Subject: Changes to PULSTAR Reactor Facility Technical Specifications

Reference: License: R-120  
Docket: 50-297

**NCSU PULSTAR Technical Specification Amendment 14  
Change Summary**

**AMENDMENT 14**

Figure 6.1-1

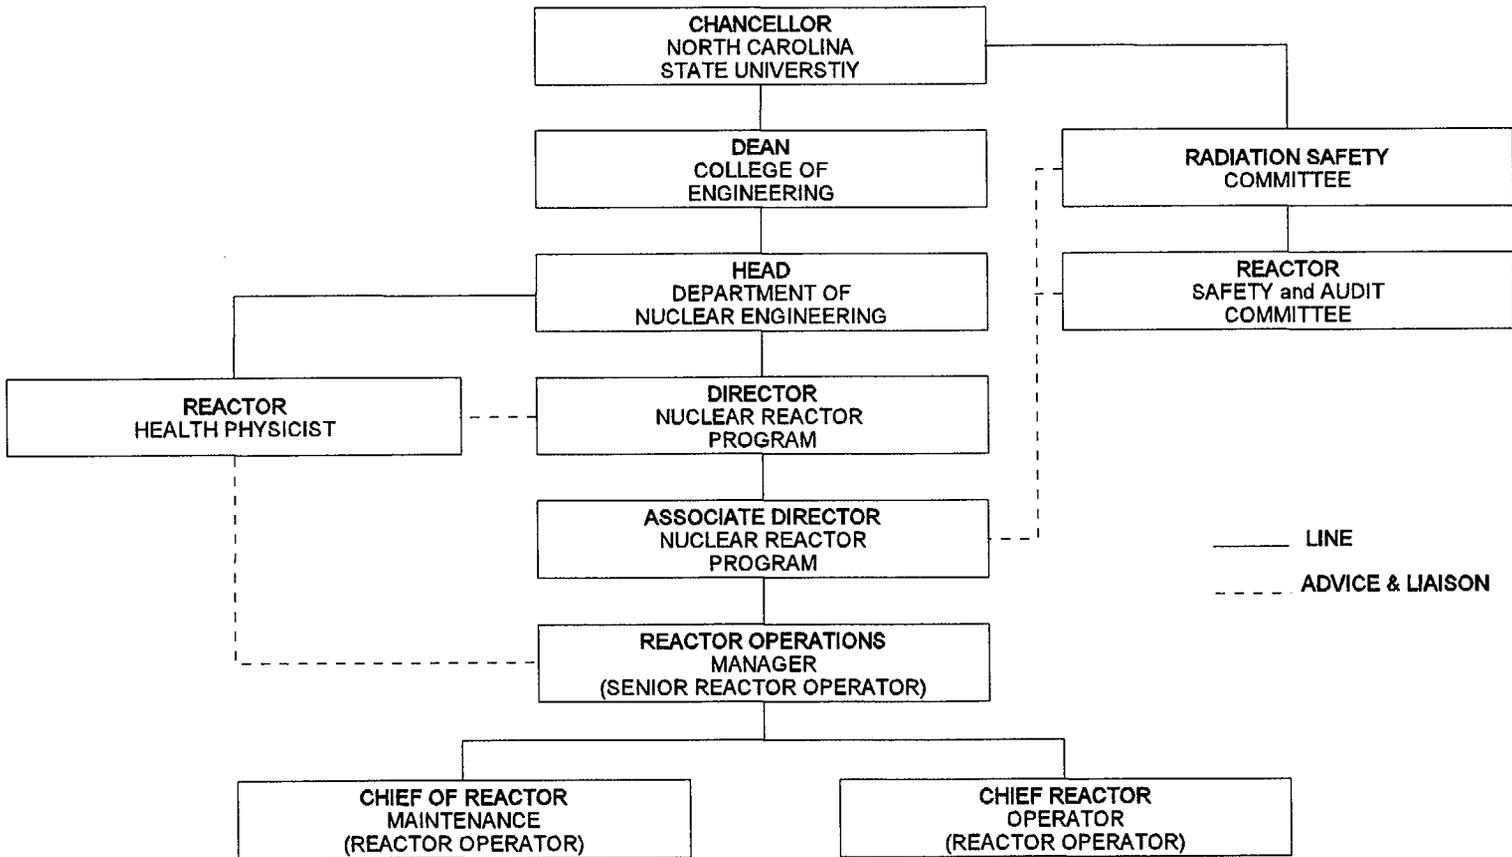
- Page 46 - Changed "Protection" to "Safety"  
- Changed "Protection Office" to "Safety Division"
- Page 48 - Changed "Protection" to "Safety" on Organizational Chart
